# Southlands Warehouse Estate Modification 3

Layout and Vegetation Changes  
State Significant Development Modification Assessment  
(SSD-9691-Mod-3)

April 2023

Published by the NSW Department of Planning and Environment

Figure 3 | Proposed Site Plan

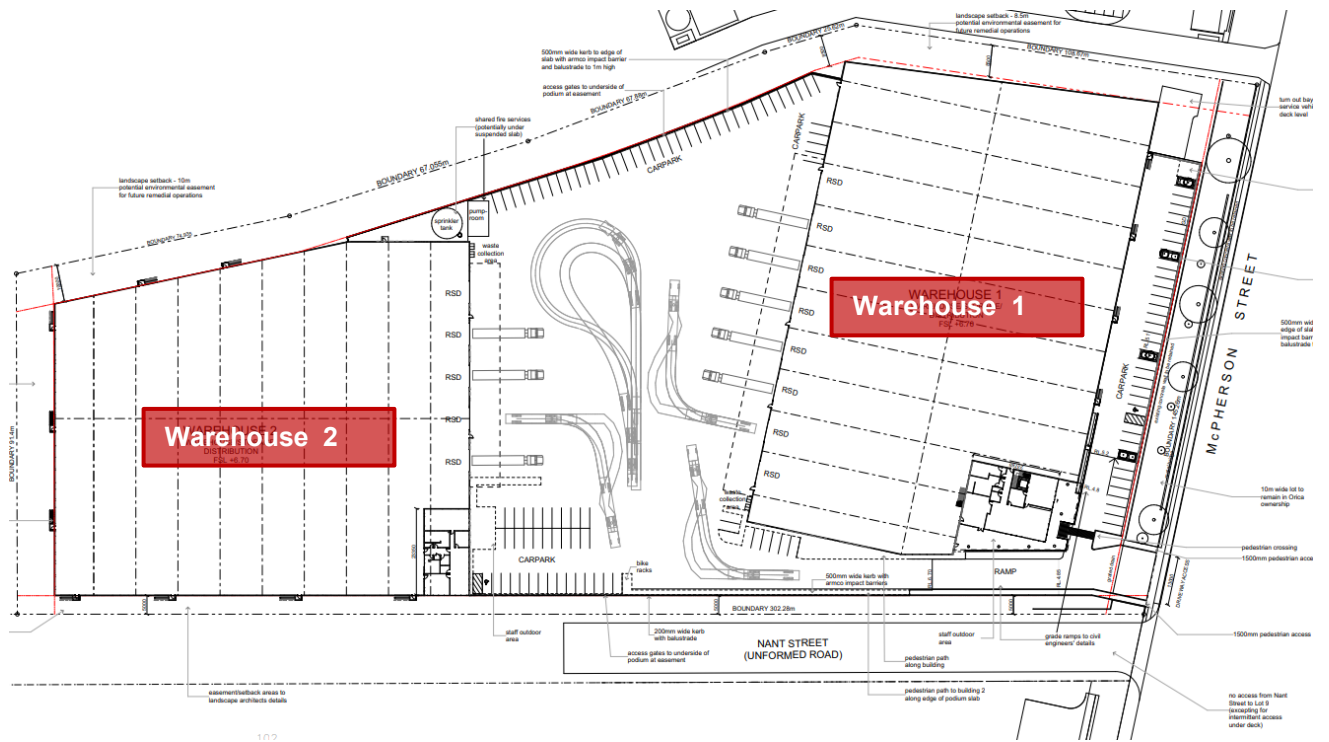
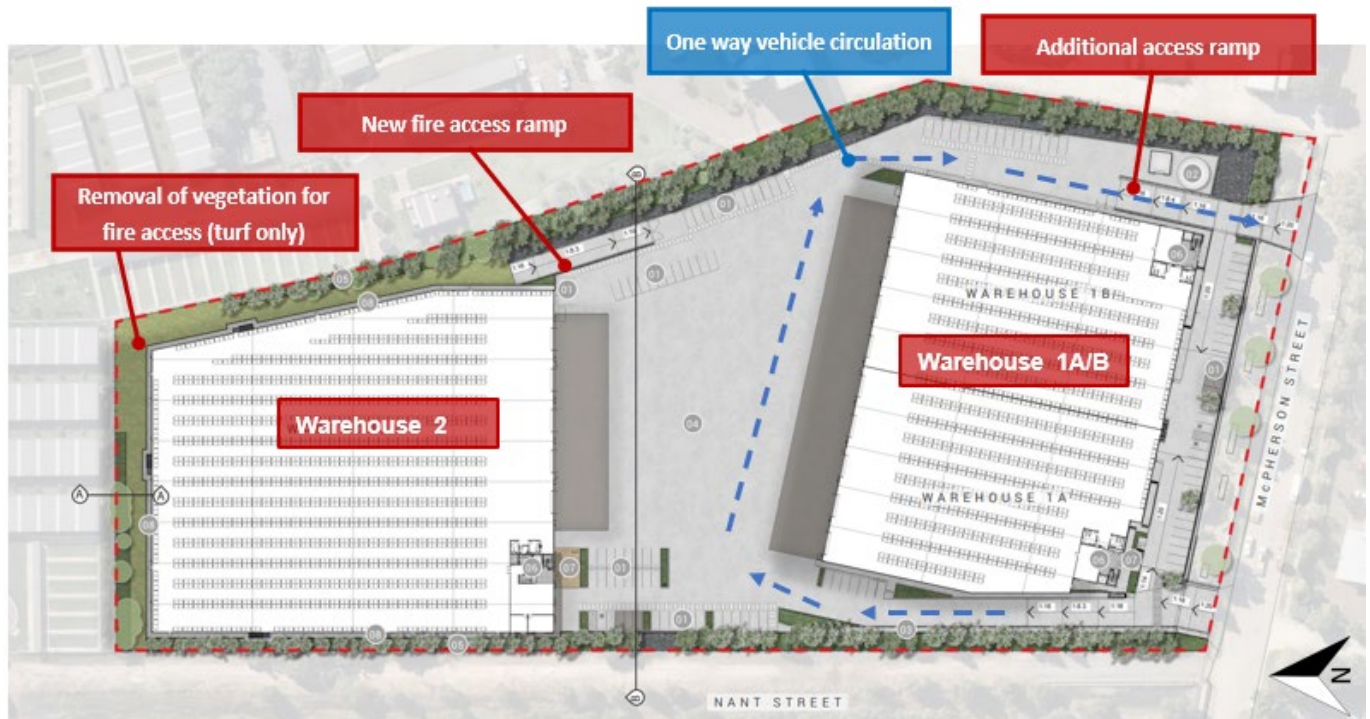
The modification is described in full in the Modification Report included in **Appendix A** and is illustrated in **Figure 2** to **Figure 8** and summarised in **Table 2**. The modification seeks the following amendments:

- reduction in warehouse gross floor area (GFA) by 2,085 square metres (m<sup>2</sup>)
- splitting of warehouse 1 into two tenancies (1A & 1B) and associated additional office space
- increase in deck height to allow for proper clearance in basin
- addition of access ramp at rear of site to allow for fire access to warehouse 2
- replacement of rear boundary vegetation with turf to allow for fire access
- changes to landscaping to remove 14 existing trees and plant an additional 39
- some movements to tree planting locations away from north east corner of site
- revision to building form and materials
- additional access ramp to McPherson Street to form one way traffic circulation
- revised car parking layout
- addition of solar panels.

The Applicant has proposed the modification in order to facilitate a better site layout with a one way ingress / egress system to suit needs of future tenants. The proposed changes to the north of the site, including the additional access ramp and some vegetation clearing is required to meet fire access requirements under the Building Code of Australia.

Figure 4 | Approved Southern Elevation

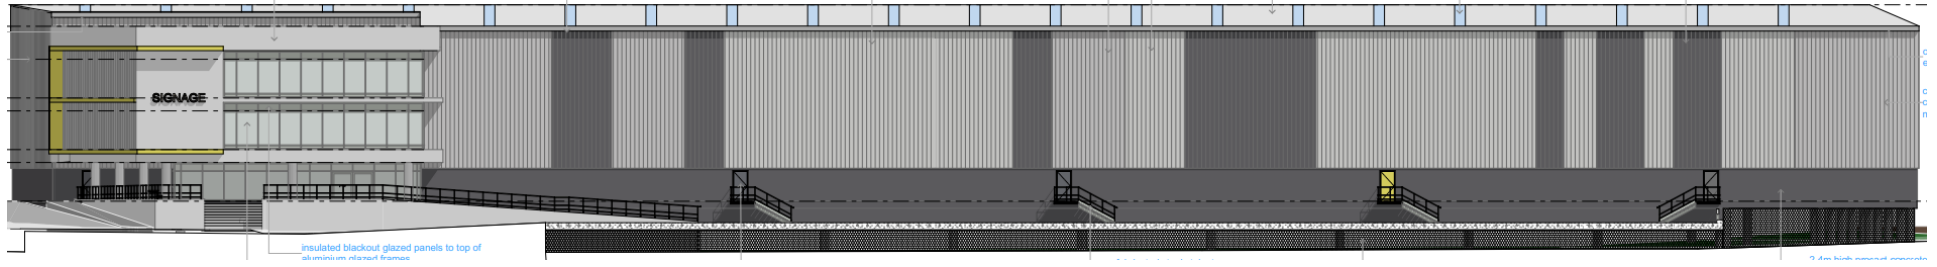
- Changes to built form and height may impact on visual amenity of the building. No changes to conditions.
- The proposal will see an increase in height by 0.2 m to allow for sufficient clearance to the detention basin below the deck and other changes, such as the splitting of the office on the McPherson Street elevation to now locate on each side and addition of solar panels.

- Council reviewed the proposal and raised no issues from a visual amenity perspective.
- The Department has reviewed the proposal and although Warehouse 1 sees a minor increase in height, the reduction in building width and the breaking up of the office space is considered to assist in adding articulation and reducing the scale and bulk of the development when viewed from the street.
